SERVICE BULLETIN

APPLICABILITY: Legacy, Impreza and Forester Vehicles **NUMBER:** 02-93-04
SUBJECT: Modification of Timing Belt Tensioner **DATE:** 11/05/04
 Bracket

Figure 1

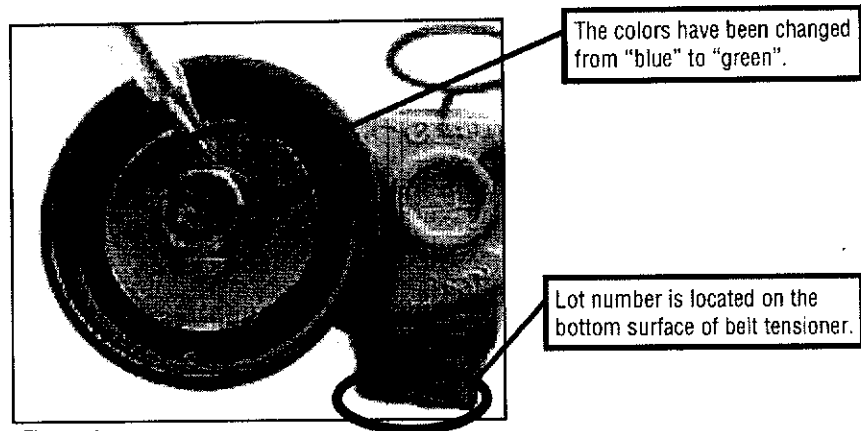
The color of the paint dot on the pulley bolt was changed from "Blue" to "Green" (see Figure 1)
Lot number of belt tensioner: 020402 and after.

Figure 2

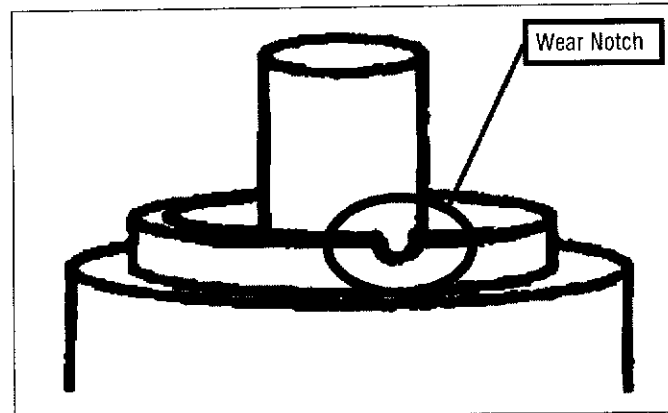
- (2) Confirm if the noise is coming from the upper portion of the timing belt tensioner by using a stethoscope. If noise can be heard it's either coming from the tensioner or bracket. Inspect the belt tensioner; if the cylinder body of the timing belt tensioner has a notch from wear (see Figure 2) the tensioner will need to be replaced.
